TO: City Plan Board

DATE: June 23, 2016

SUBJECT: Petition PB-16-50 SUP: Boos Development Group/CHW, agent for Jeff Montgomery Associates, LLC, owner. Special use permit with development plan review for construction of a new commercial development with drive through. Zoned: MU-1 (8-30 units/acre mixed use low intensity). Located at 4322 NW 53rd Avenue.

STORMWATER INFRASTRUCTURE ARE REQUIRED TO COMPLY WITH THE FOLLOWING STANDARDS:

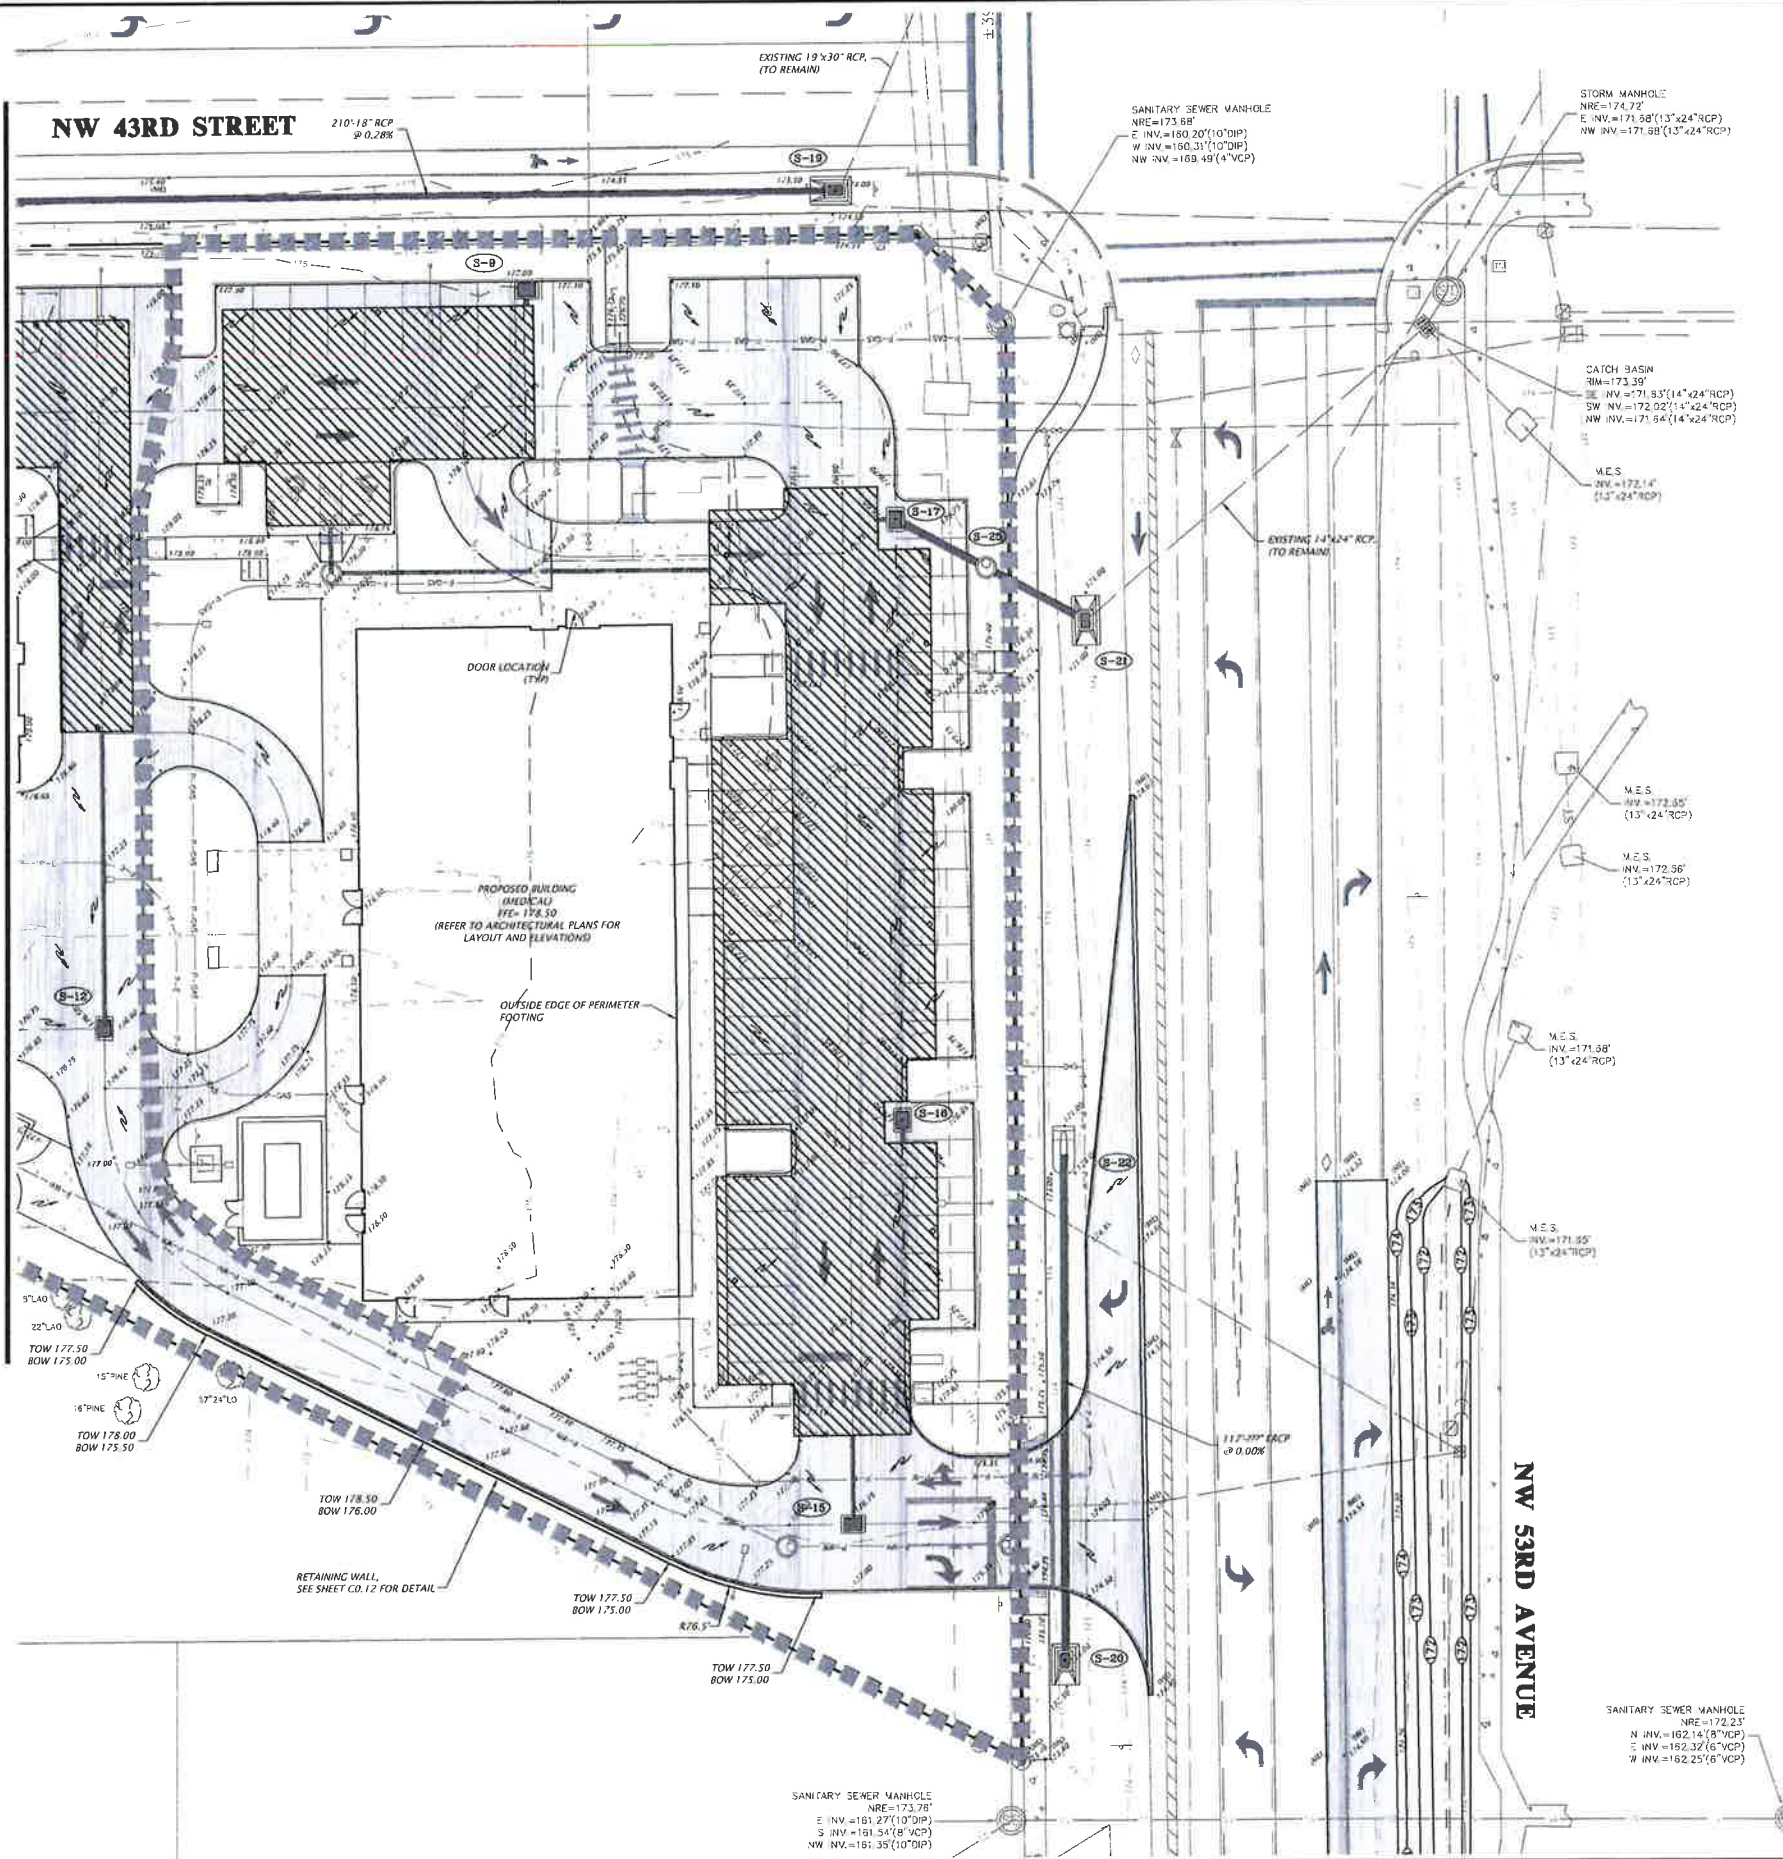
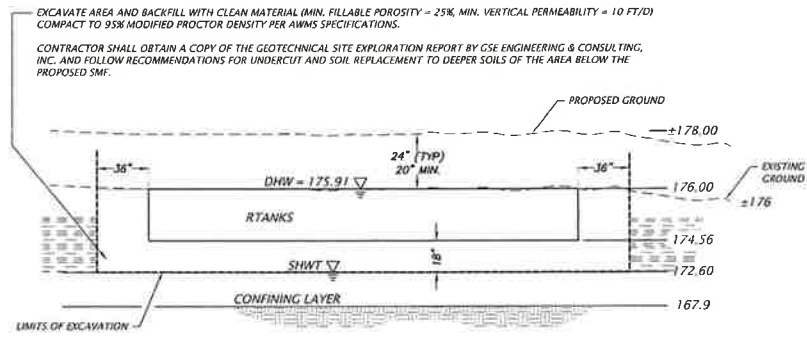
1 - For SMF-1, it appears the structure S-1 would be the lowest inlet top associated with this facility. Currently, the calculations show that .09 feet of freeboard is provided within the stormwater facility. The additional storage can be provided in the proposed parking lot, but S-1 would drain directly into the right-of-way.

1. Where does the stormwater collected from inlets S-1 and S-2 being treated?
 - **Storm network has been revised and collection is provided. See Sheets C2.00, C2.01, C2.02, and C2.30.**
2. The post-developed discharge rate exceeds that of the pre-developed amount for the 100 year, 2 hour and 100 year, 4 hour storm events.
 - **Cumulative post-developed discharge rates are now below the pre-developed rates.**

DRAWING NUMBER:
LS-1

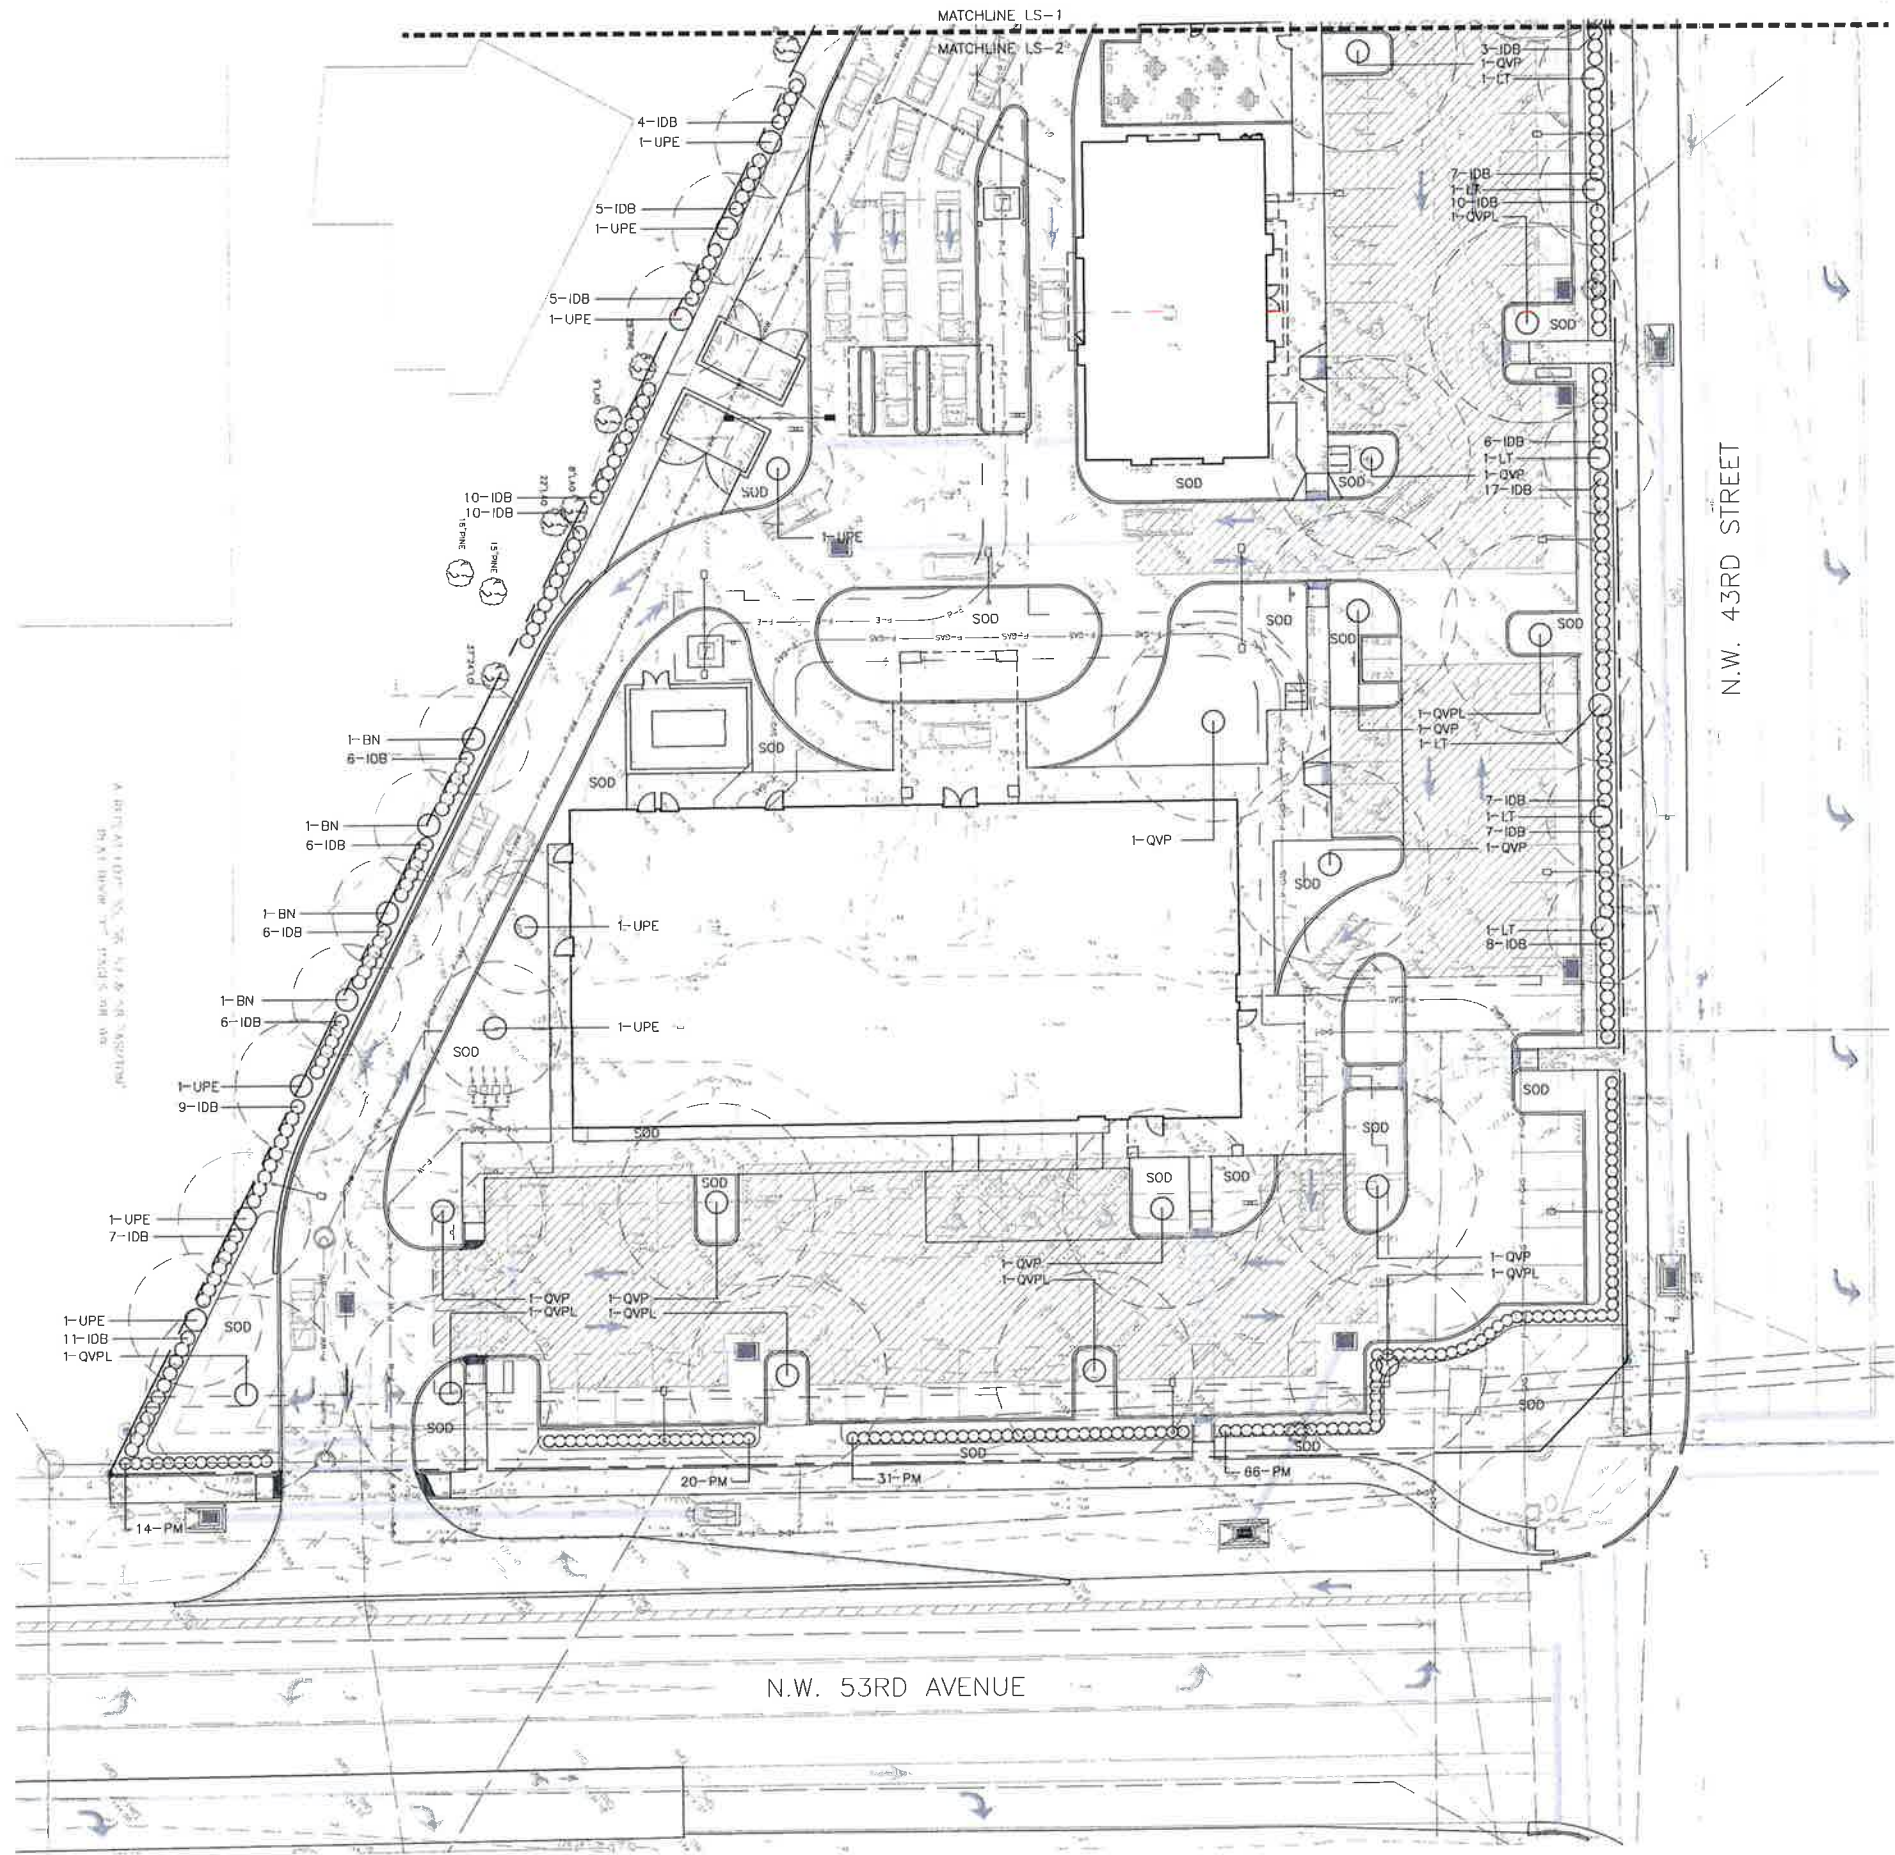
8. The palms along the western property line needs to be replaced with shade trees. (sheet LS-1)
 - **The palms have been replaced, as requested.**

12. Please add a shade tree behind or beside the dumpster pad.
 - **A shade tree has been provided by the dumpster pad.**
13. Please replace the Crape myrtles with Little Gem Magnolias trees. (Sheet LS-2)

Drawing Number
E-1

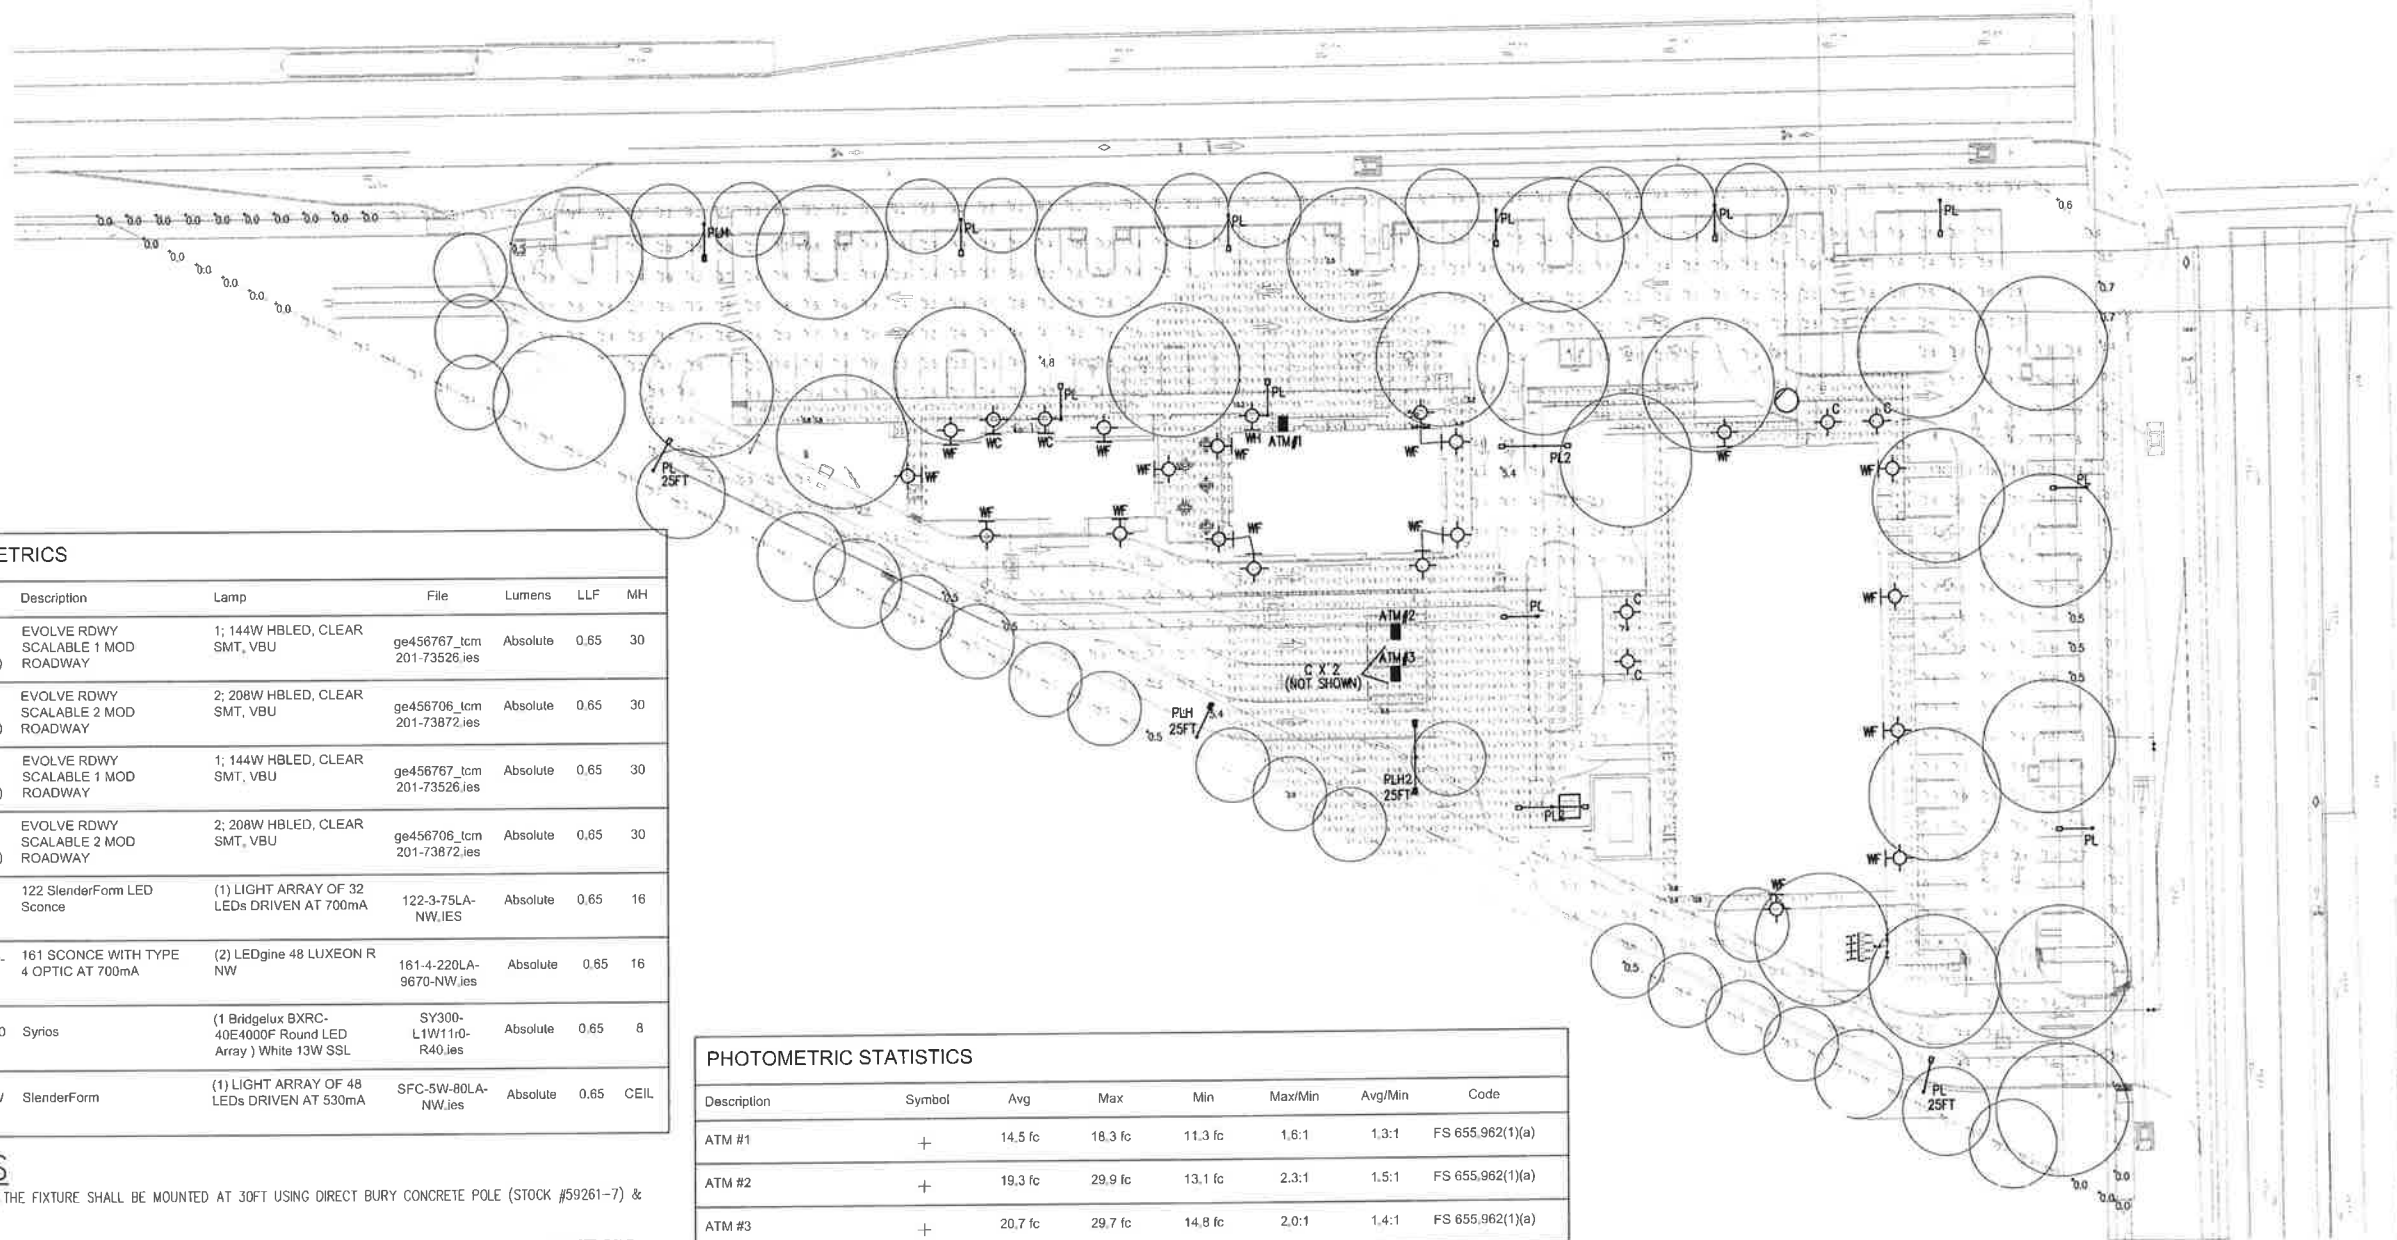
Condition 4. *The photometric plan shall be amended to reduce spill-over lighting onto the adjacent property to levels allowed by the code. Alternatively, appropriate screening methods shall be employed to reduce the impact of the ATM lighting on the adjacent property. All light fixtures shall be designed and placed so that there is no direct lighting onto the adjacent neighborhoods. An automatic system shall be provided to lower lighting to security levels after operating hours.*

- b. The spill-over lighting onto the adjacent property to the west can be avoided; please address.
 - c. Staff recommends landscaping, fencing, screening or other lighting modifications to address the spill-over lighting in the area.
